Illustrated Parts List - IPL Update

H555

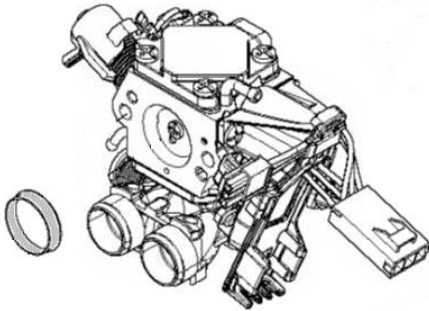
1. A new Inlet pipe, assy 583 96 41-03/-04 have been introduced. The change has been made to ensure the assembly and to avoid leakage.
2. The New Carburetor, kit 501 46 33-06 consist of: New Carburetor ZAMA140059A, a separate support sleeve 582 02 51-01 and AT-instruction.
3. New article number and some minor changes on Air Nozzle due to change of supplier.

1. Carburetor

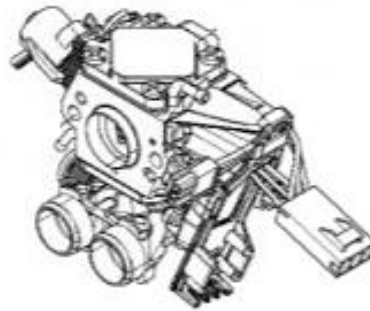
New version

501 46 33-06, ZAMA140059A

Old version

501 46 33-04, ZAMA140056A
